Paul Still's Responses to DEP Responses

Comments and Request for a Public Meeting Regarding the Draft IWW Permit for the Florida Mine - Trail Ridge

File Number FL0000051 015 IW3S

Figure 2

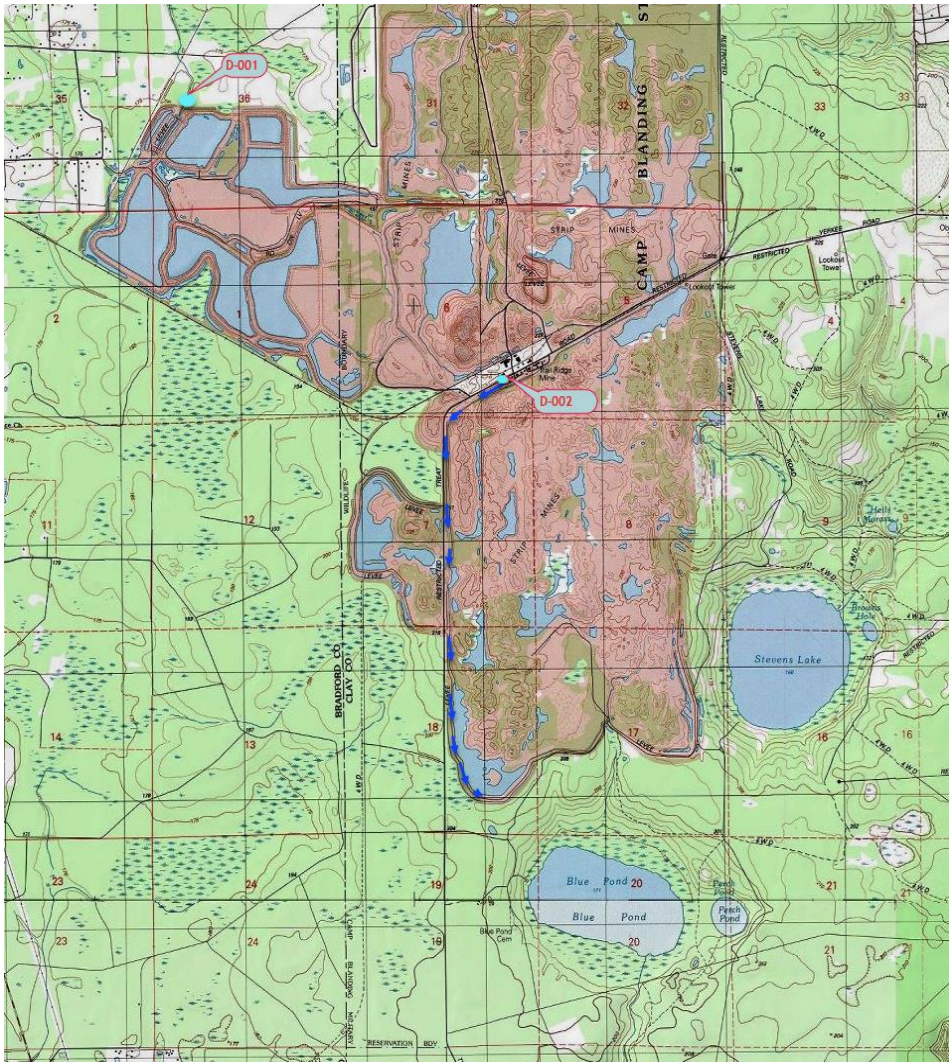
Mr. Paul Still's follow-up comment: *The above fails to address the concern that the flow of water through the old mined area could impact Blue Pond water quality by the addition of substances that would cause the water entering Blue Pond to meet regulatory standards.*

DEP Response: *Chemours has monitored the water quality before discharging from Outfall D-002, and due to the high elevation of the trip mines (i.e. "the old mined area"), water discharging from the Outfall D-002, would not flow through the old mined area. The water discharging from the Outfall D-002 should mostly flow through a drainage ditch running along the side of the Treat Road to the Blue Pond (Please see Figures 1 and 2 below).*

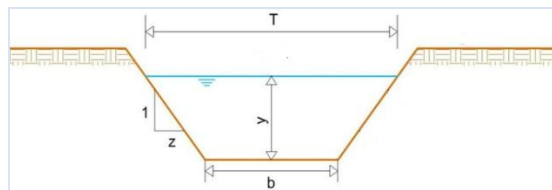
Mr. Paul Still's follow-up comment: *The above table and conclusions are not valid because they only represent the percentage of flow at Lake Rowell. As you move upstream the percentage of flow from Chemours would increase. Calculations should be done for the segments of Alligator Creek upstream from the following 301, SR 100, Laura Street, SR230, Bradford Court, and NE 17th Ave.*

DEP Response: *The calculations included stormwater runoff from 2.59 square miles of drainage area of Chemours – Trail Ridge and with different discharging capacity from the Outfall D-001.*

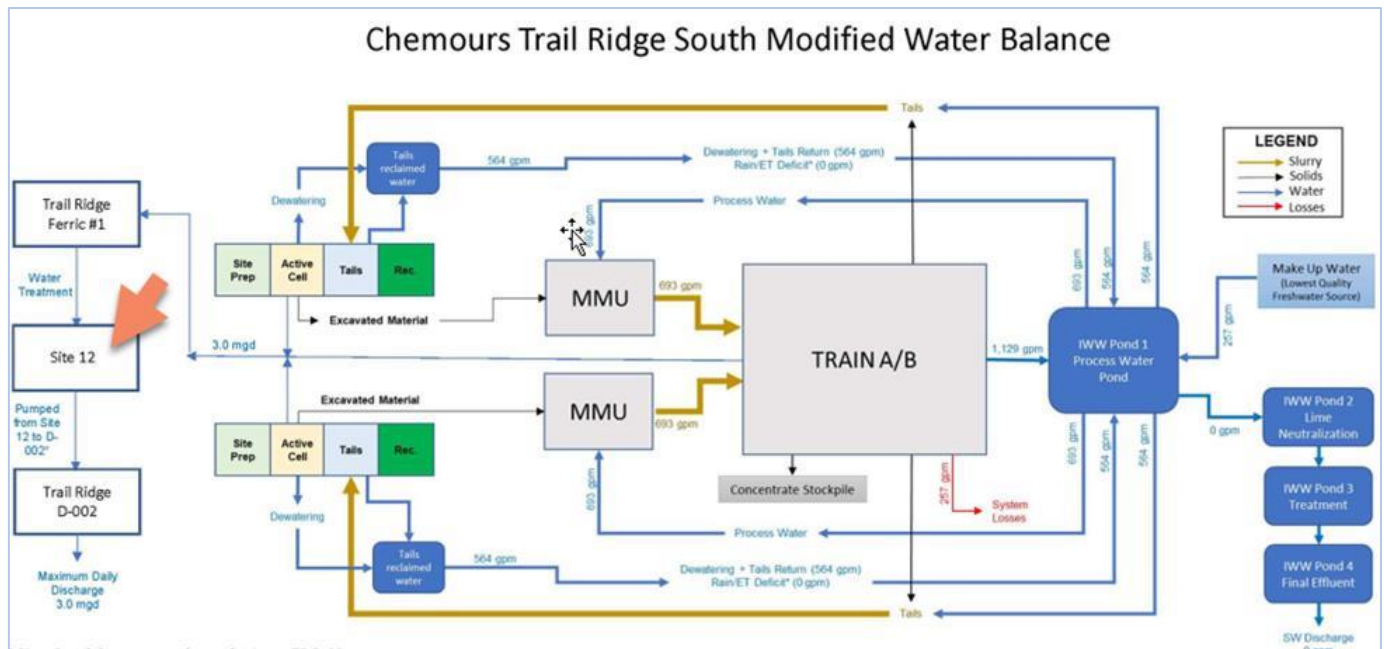
Water from the Trail Ridge South Mine should be monitored either at the point it is withdrawn or the point it enters the Florida Mine-Trail Ridge IWW. *B. Surface*

Water Discharges (Outfall D-002) (Temporary) could be written to make it apply to the water from the Trail Ridge South Mine.

If B.1. is **deleted** all of B. would also be deleted.

DEP Response: Trail Ridge South has an approved outfall at D-001 to Double Run tributary. This is the preferred discharge outfall, as transfer to Trail Ridge requires active pumping.

Figure 2: Water Balance Map:

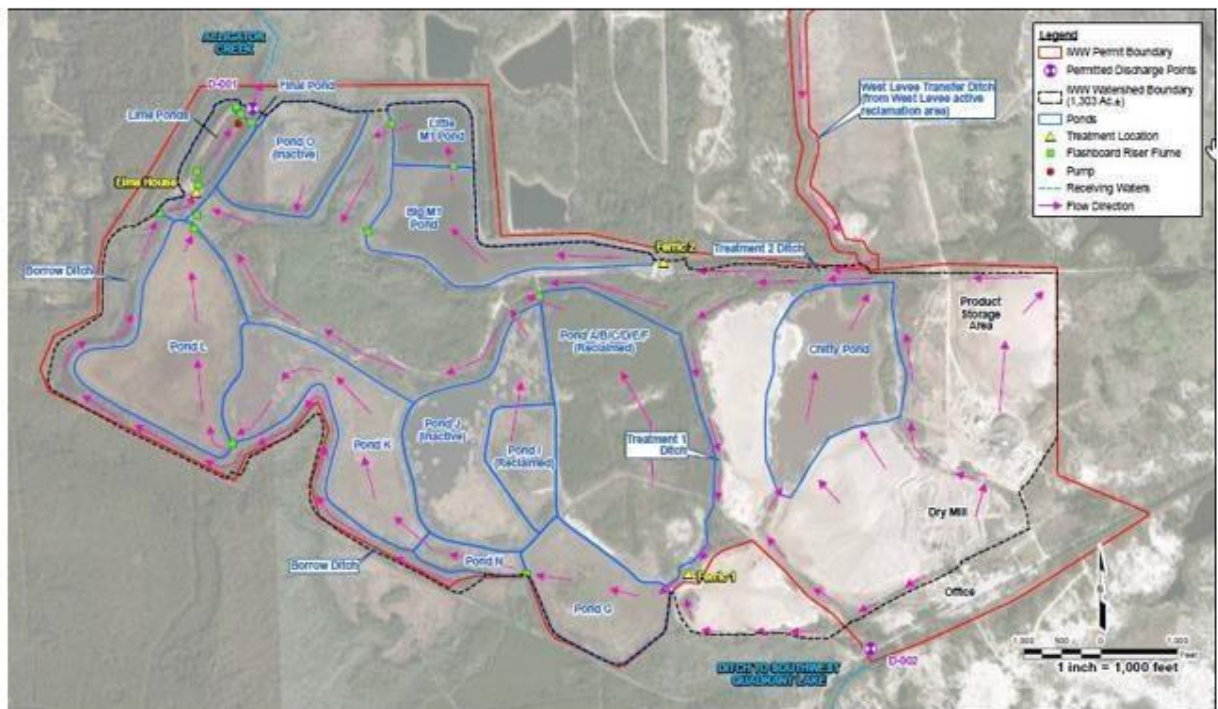
The IWW Permit Boundary in red should be expanded to the Chemours Bradford County property lines on the west and south of the ponds. The current location of the pump (red dot) needs to be verified.

Responding to Consent Oder (OGC File No. 18-1240, dated January 2, 2020), Chemours/Kleinfelder conducted a Plan of Study of Active Wastewater Treatment Pond Seepage Evaluation Trail Ridge and a [Pond Seepage Evaluation](#) was submitted. Based on the results of Kleinfelder’s treatment pond seepage evaluation conducted between August 2020 and July 2021, dye introduced into the toe/borrow ditch manifested only temporarily with the toe/borrow ditch and did not migrate to downgradient groundwater or surface waters; no Rhodamine Water Tracer (RWT) dye tracing was detected in the adjacent offsite flow way ditch or in groundwater of the exterior berm walls downgradient from the insertion point.

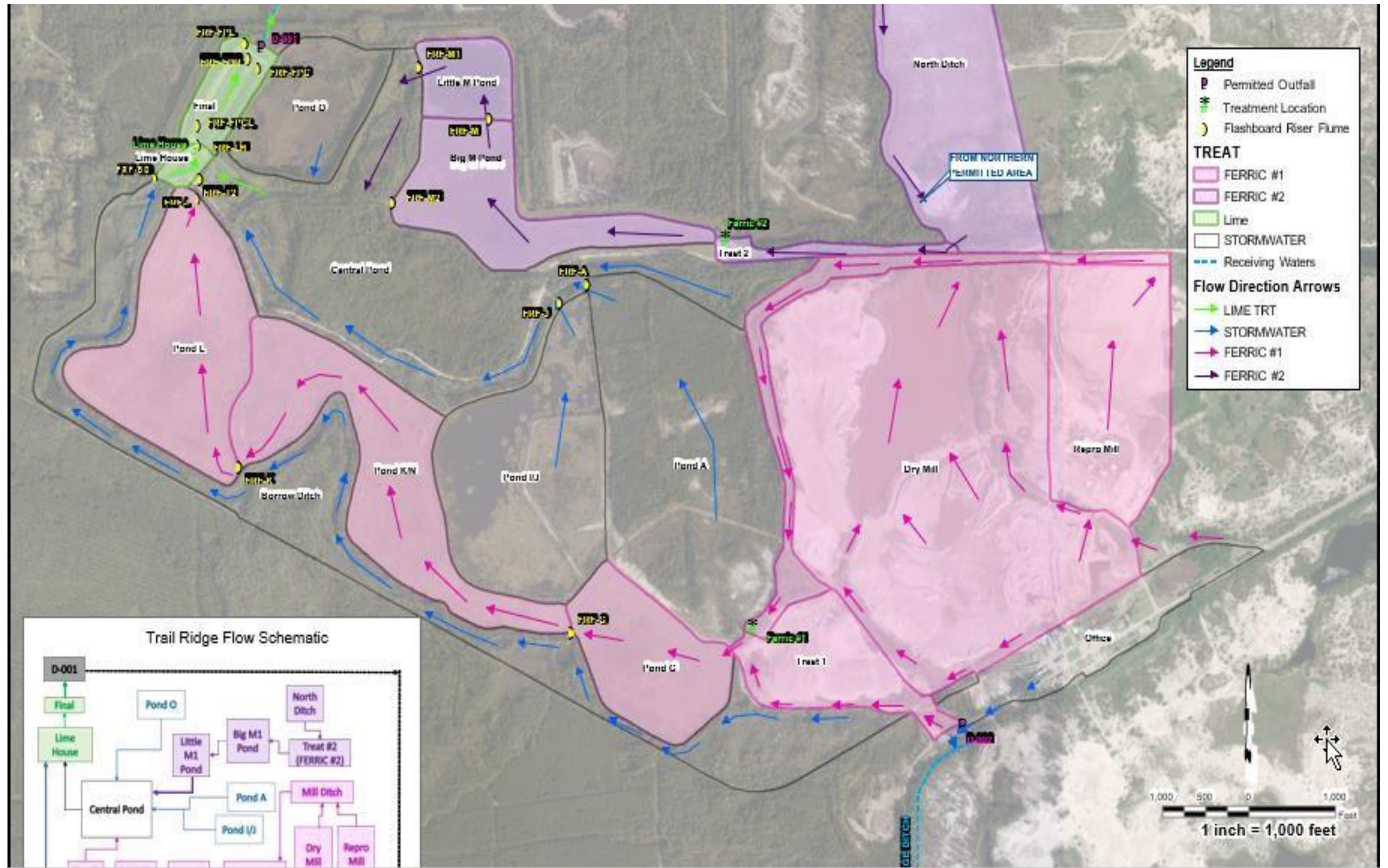
The Owen does clearly document that water flows offsite from the Borrow Ditch onto railroad property.

If Trail Ridge South industrial wastewater is transferred to the Florida Mine -Trail Ridge facility, unmonitored discharges from the Borrow Ditch of Radium 226+228 would be an added concern.

Actions to address the discharges from the Borrow Pit system need to be made a part of the Draft Permit.

Chemours has failed to provide reasonable assurance that it is not discharging industrial wastewater offsite from the Borrow Ditch to the railroad and NFLT properties that then flows through neighborhoods to Alligator Creek upstream of Bradford Court.

Trail Ridge Flow Schematic

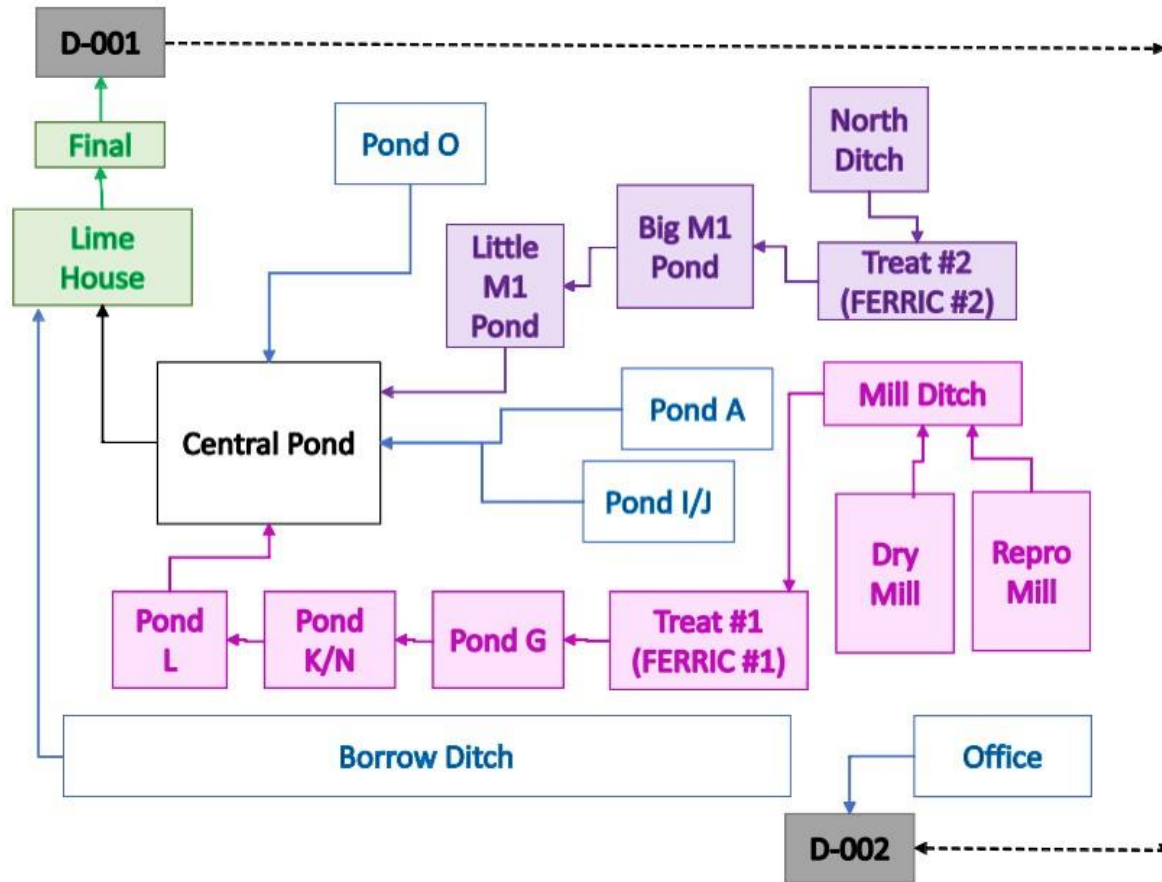
In the above the black dotted line from D-001 to D-002 should start after “Final” not D-001.

Mr. Paul Still’s follow-up comment: The above fails to show the overflow pipe that allows flow from Pond L to flow into the Barrow Ditch. Has Chemours permanently blocked any water from flowing through the overflow pipe?

Mr. Paul Still’s follow-up comment: The above fails to show the flow out of the Borrow Ditch over and under the rail line. That flow is not monitored for quality or volume and enters Alligator Creek downstream of NE 17th Ave and upstream of Bradford Court.

Response: While the Department agrees with the above statement, the schematic shown above does not depict a significant change in water quality. Schematics in Appendix B depict the flow of the effluent.

DEP Response: There is no flow from Pond L to the Borrow Ditch.

DEP Response: *Please see the Pond Seepage Evaluation for additional information.*

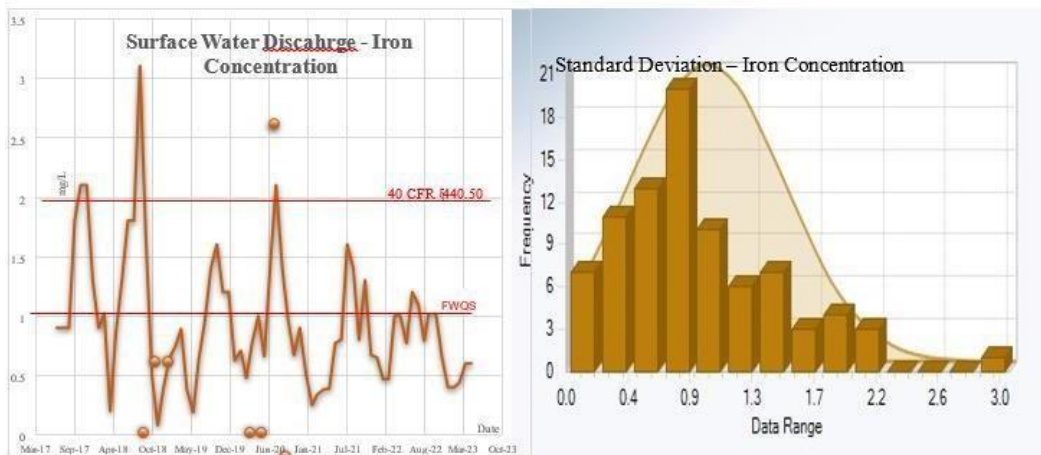
data shows that 31.76 % samples/observations having iron concentration exceeded the Florida WQS of 1.0 mg/L but below 2.0 mg/L, which is a daily maximum iron concentration allowable based on EPA – TBEL (40 CFR Part 440 – Ore Mineral Mining And Processing Point Source Category, Subpart E (§§440.50-440.55)); Monitoring data shows also that 4.70 % (i.e. 4 out of 85) samples/observations have iron concentration exceeded 2.0 mg/L. Chemours shall continue to monitor for iron and require to demonstrate that the discharge would the Department regulations of iron.

(Correct spelling of Discharge in the graph on the left.)

The graph shows iron concentration tends to increase after May. The May data should be added to the graph as should the June data when it becomes available.

The Administrative Order associated with the expired IWW Permit had the provision “When the previous 24-hour flow proportional composite sample for which results have been obtained is above 0.8 mg/L, 24-hour flow proportional composite sampling will be undertaken every third day until results indicate the level is below 0.8 mg/L.” The iron data presented in the Fact Sheet does not appear to contain the results from the extra sampling reported by Chemours in the AO 185 NE-Status Report. The data from the 2021 AO 185 NE-Status Report is copied on the next page. All the iron level data collected by Chemours should be included in the graph of Surface Water Discharge - Iron Concentration.

DEP Response: Since the expiration of the administrative order (AO 185 NE), which accompanied the past permit, the facility has reported iron exceedances at their D-001 outfall.
